Project Title: TRACT H SAWMILL **Building Permit #:** _____ **Hydrology File #:** _____
DRB#: _____ **EPC#:** _____ **Work Order#:** _____
Legal Description: TRA A-2 PLAT OF TRACTS A-1 A-2 AND A-3 LANDS OF WILLIAM ANDREW MCCORD CONT 20290AC **UPC:** 101305817952322307
City Address: 1921 BELLAMAH AVE NW ALBUQUERQUE, NM

**RE: TRACT H SAWMILL
1921 BELLAMAH AVE. NW
TRAFFIC CIRCULATION LAYOUT RESPONSE TO COMMENT**

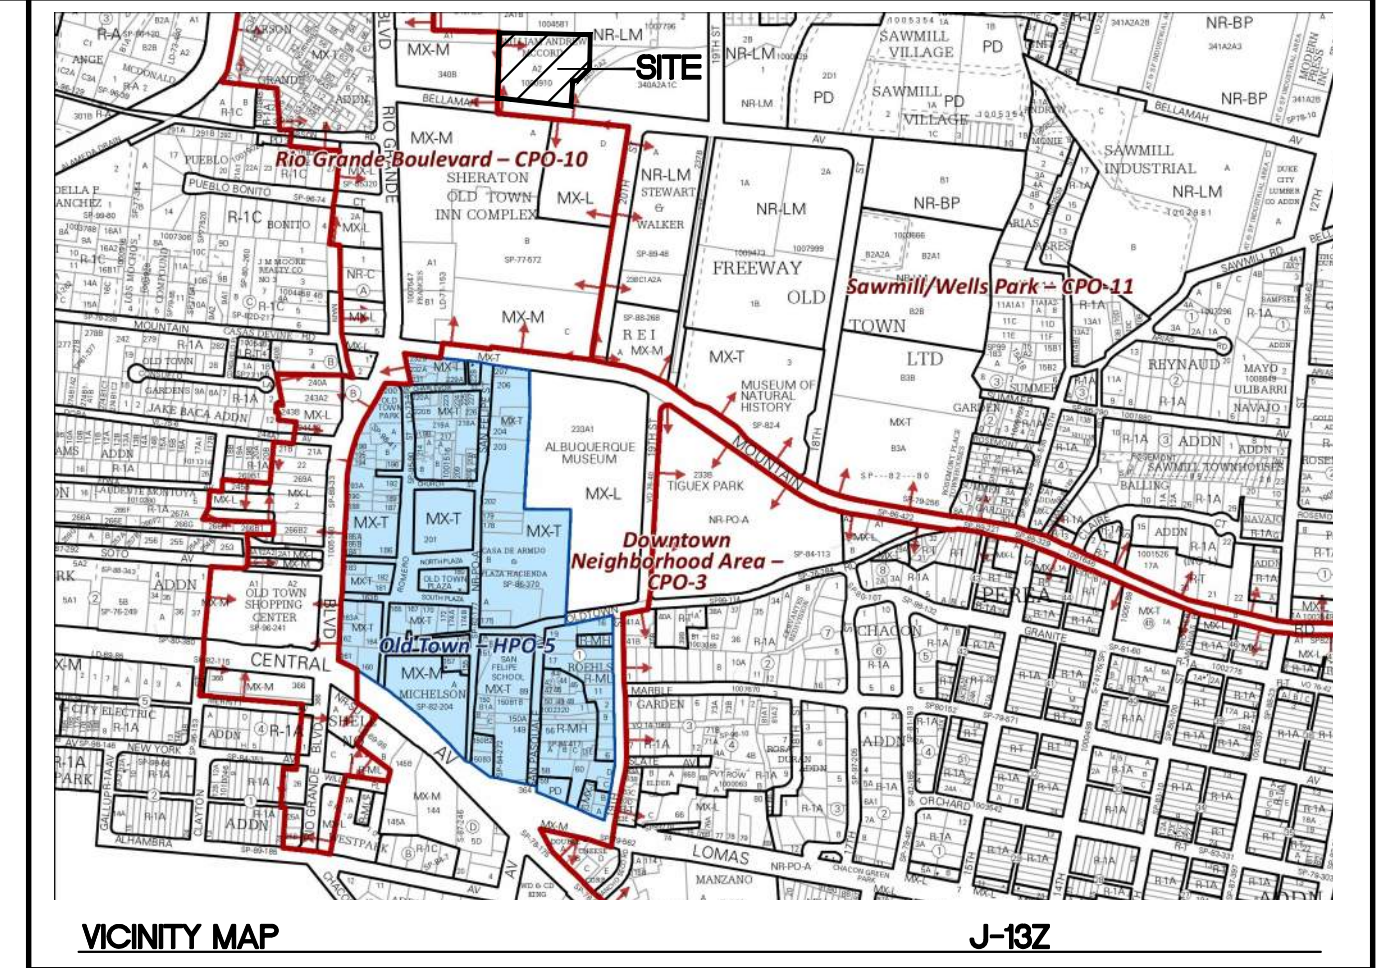
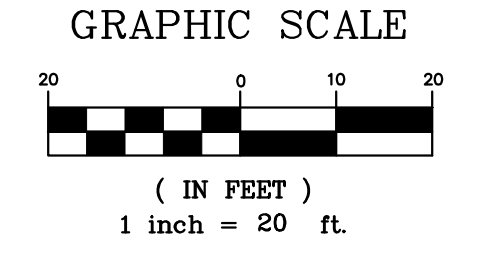
1. Site Access: Please provide Curb Return design for the driveways access of Bellamah Ave. and reference COA std dwg. 2426. Also, the One Way drive (Exit Only) shall have "Do Not Enter" signage and pavement marking. Please provide details for signage and pavement marking. Please note that the GIS shows there are two existing curb return driveways access.
We have added curb returns to the access locations and placed the one way markings requested.

2. Please reconfiguration parking spaces layout. The parking layout should provide continuous flow of traffic through the lot.
All of the parking shall be via valet parking. We've added a note to the plan stating such which should allow for the double parking shown on the plan.

3. ADA curb ramps must be updated to current standards and have truncated domes installed.
All ADA curb ramps are to current standards and show the truncated domes.

4. Per the IDO, a 6ft. wide ADA accessible pedestrian pathway is required from the public sidewalk to the building entrances. Please clearly show this pathway and provide details.
The ADA route is now shown on the plans via a thick dashed line. This area is all sidewalk and a detail is shown on Sheet DET-1.

5. Per DPM, a 6 ft. wide ADA accessible pedestrian pathway is required from the ADA parking stall access aisles to the building entrances. Please clearly show this pathway and provide details.
The ADA route is now shown on the plans via a thick dashed line. This area is all sidewalk and a detail is shown on Sheet DET-1

6. Define ADA pathways by labeling of ramps, flush pavement, dimensioning of pathways, doorways, etc.
The ADA pathways are defined on the plans as requested.

7. ADA accessible pedestrian pathway should not be placed behind parking space or adjacent to a vehicular way. Vehicle and pedestrian/wheel chair conflicts should be avoided as much as possible.
The ADA route from the ADA parking to the building is in front of the parking stalls and does not have any pedestrian/vehicular conflicts.

8. Parking areas shall have barriers to prevent vehicles from extending over public sidewalk, public right-of-way, or abutting lots.
Parking bumpers were added to the four parking spaces where this occurs.

9. Refuse vehicle maneuvering shall be contained on-site. The refuse vehicle shall not back into the public right of way. Provide a copy of refuse approval.
The refuse is located in the northwest corner of the site and does not conflict with the public right of way.

10. Provide a copy of Fire Marshal approval.
The approved Fire One Plan is attached.
11. It is not apparent what type of pavement surface is being proposed. A hard driving surface will be required as part of this proposed project for parking area and drive aisles.
All paved areas shall be asphalt unless otherwise specified on the site. A note was added to the plan stating this.

12. Please specify the City Standard Drawing Number when applicable.
The City Standard Drawing Numbers are listed where applicable.
13. Add a note stating, "All broken or cracked sidewalk must be replaced with sidewalk and curb & gutter." A build note must be provided referring to the appropriate City Standard drawing.
This note was added to the Site Plan.
